N1092D-03

Information Only Service Note

N1092D DCA-M Sampling Oscilloscope

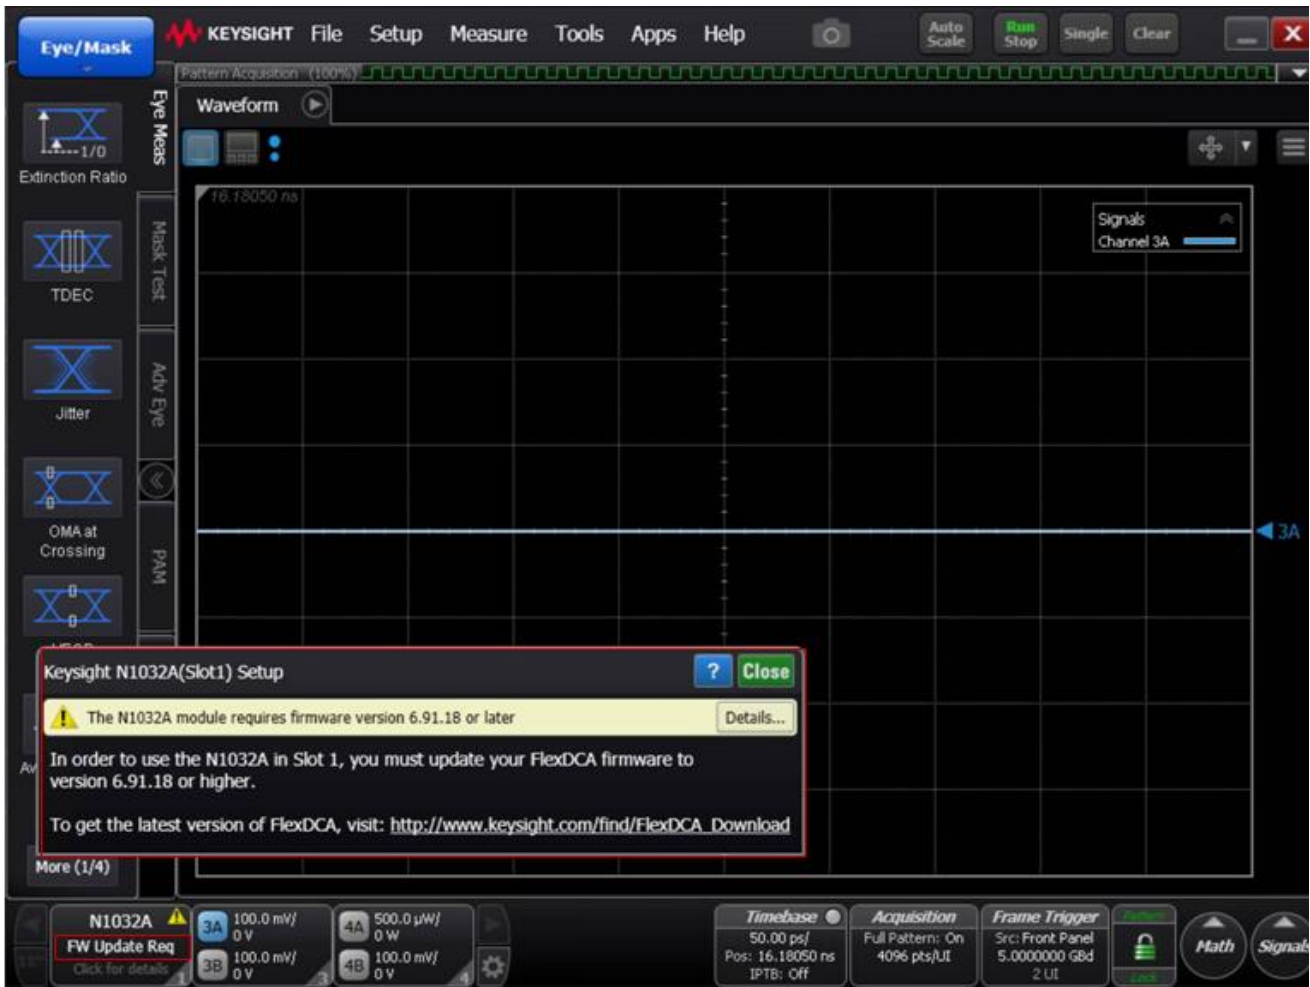
A message will be displayed in FlexDCA if a newer version is required.

With the instrument connected to FlexDCA, if a message like the one below is displayed, FlexDCA must be updated to the indicated version (or later):

To update FlexDCA software, download from www.keysight.com/find/flexdca_download and install. While only the indicated version is required, updating to the latest version is recommended.
